Subject: Draft SSAR changes to support the senior management meeting

Attached are draft SSAR changes to provide a site interface on soil variability. These requirements are to be added to subsection 2.5.4.5.2 as a COL requirement. Also provided is a new subsection 3.8.5.4.3 to be added provide limits on construction sequence.

### OPEN ITEM #5 (RAI 410.263)

SUBJECT: WESTINGHOUSE RESPONSES TO NRC REQUESTS FOR ADDITIONAL  
INFORMATION ON THE AP600

2.5-4  
Figure 2.5-4

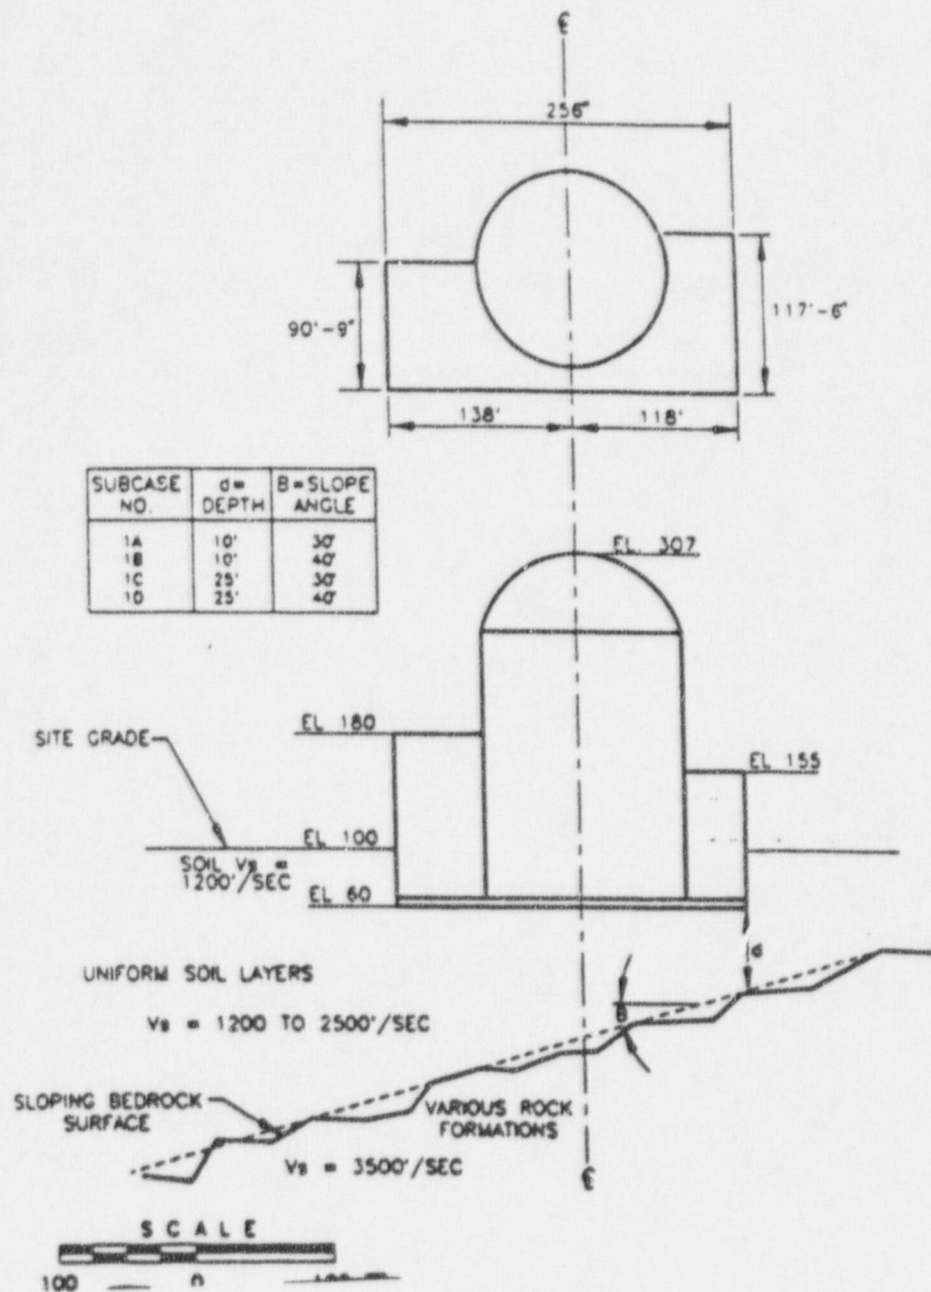
A geologically impacted site as shown on Figure 2.5-4 is one where the bedrock has abrupt facies change or has been interrupted either by a fault (shear zone) or by an intrusive such as a dike. This leads to the possibility of lateral variation in the bedrock properties affecting soil structure interaction and bearing pressure. Three subcases are identified. The first type

Investigations for a geologically impacted site must define the width of the zone of the higher (or lower) shear wave velocity. The location of the zone of higher (or lower) shear wave velocity must be determined in relation to the center of containment. The azimuths of the bounding postulated vertical planes of the higher (or lower) shear wave velocity must be determined.

The zone of the higher (or lower) shear wave velocity has been shown in Figure 2.5-4 bounded by non-curvilinear vertical parallel planes. It is recognized that such a situation is highly unlikely in nature. A procedure similar to that described in subsection 2.5.4.5.2.1 for identifying the horizontal layers of uniform sites can be used to define the nearly vertical planes of a geologically impacted site. Deviations between the site condition and the idealized postulated situations on the order 5 percent are considered acceptable.

2.5-2  
Figure 2.5-2

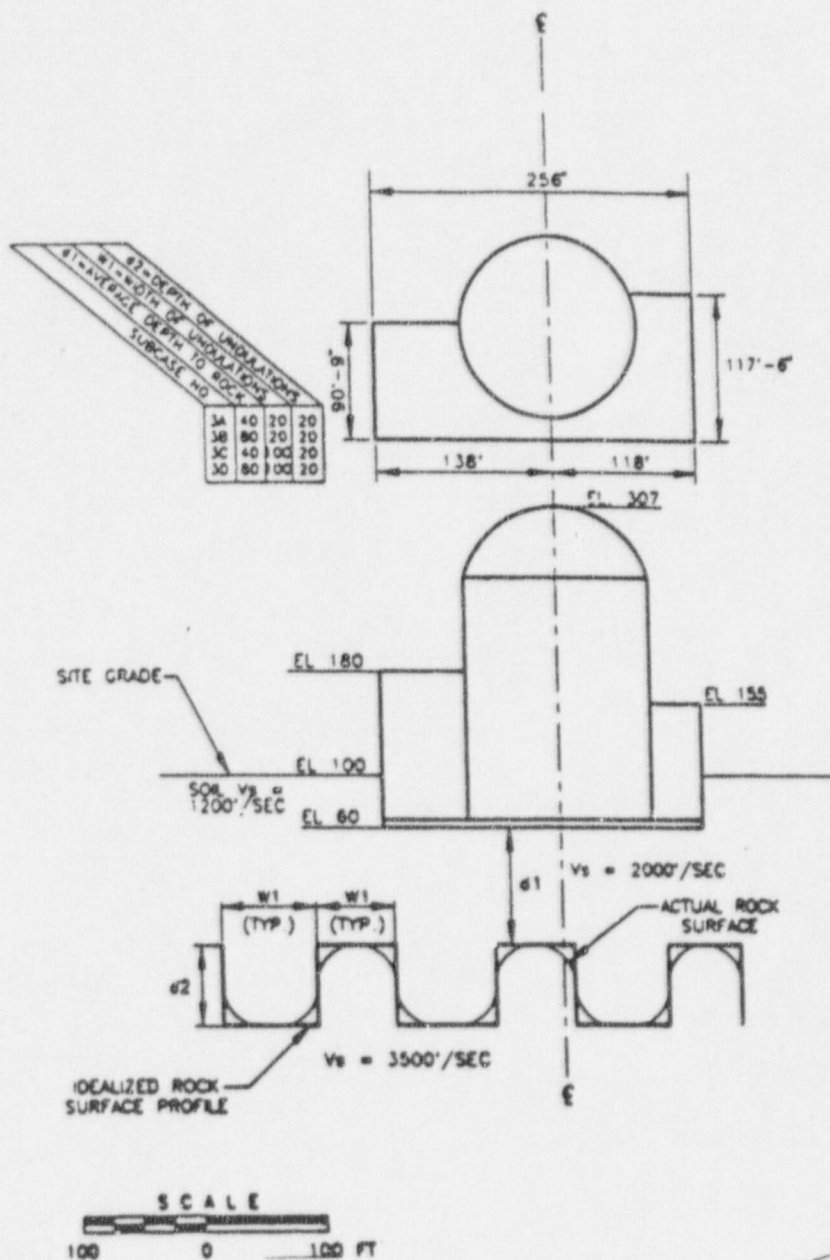
The sloping bedrock site as shown on Figure 2.5-2 is typical for a river front site where in the geologic past the bedrock has been eroded to a valley slope and then the valley was subsequently filled with alluvium. The bedding in the rock is nearly horizontal, but the surface of the rock is sloping on a strike parallel to the direction of the river. The shear wave velocity of the uniform soil layer overlying rock may vary between 1,000 and 2,500 feet per second. The shear wave velocity of 3,500 feet per second for the bedrock is representative of sites with a sloping rock surface. Sites where the bedrock has much higher shear wave velocities are not likely to exhibit such conditions.

Investigations for a site with a sloping bedrock surface must define the depth to bedrock as a function of plan location and the shear wave velocity of the overlying soil and bedrock. The bedrock profile can be identified in the same manner as described in subsection 2.5.4.5.2.1 for the various layers for a uniform site. The same criterion, i.e., deviations up to 5 percent of the depth are acceptable. More borings may be necessary than required for a uniform site in order to establish the variation in depth to bedrock within the nuclear island footprint.

2.5-3  
Figure 2-5

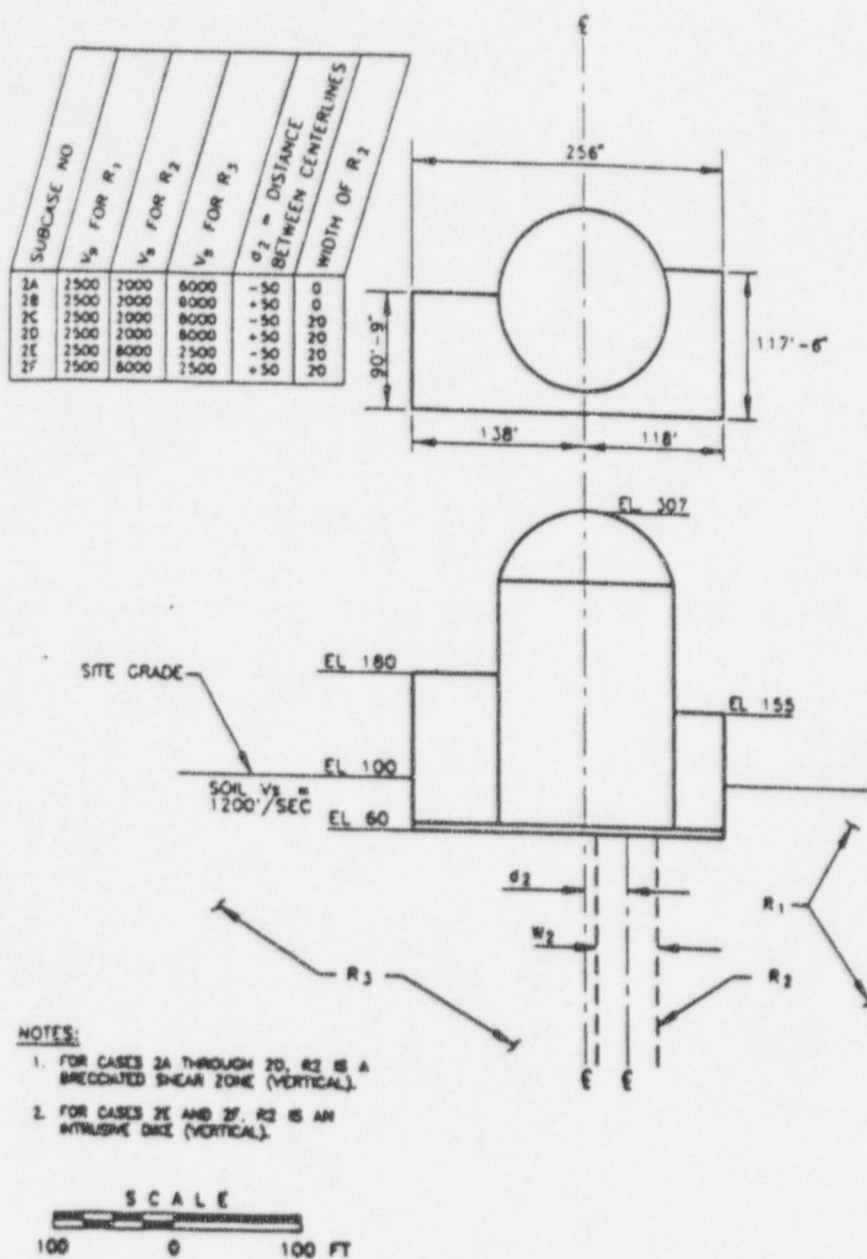
An undulatory bedrock site as shown in Figure 2.5-3 is one where the bedding planes in the bedrock are (or nearly) horizontal but the surface is undulatory. Such a situation may occur if the bedrock surface is an erosion surface in a marine or lake environment. Another example might be a limestone site overlain by saprolite as in the southeast United States. The undulations could be the result of differential weathering or by soft zones associated with solution activity in the limestone.

Investigations for a site with an undulatory bedrock surface associated with weathering or karst condition must define the depth to bedrock as a function of plan location and the shear wave velocity of the overlying soil and bedrock. For cases with the overlying soil layer between the foundation level and the bedrock less than 40 feet, the pattern dimensions of the undulations must be defined with borings, specifically the width and depth of the undulations. Boring spacings on the order of 10 feet may be required for undulations having dimensions on the order of 20 feet in order to establish the variation in depth to bedrock within the nuclear island footprint.
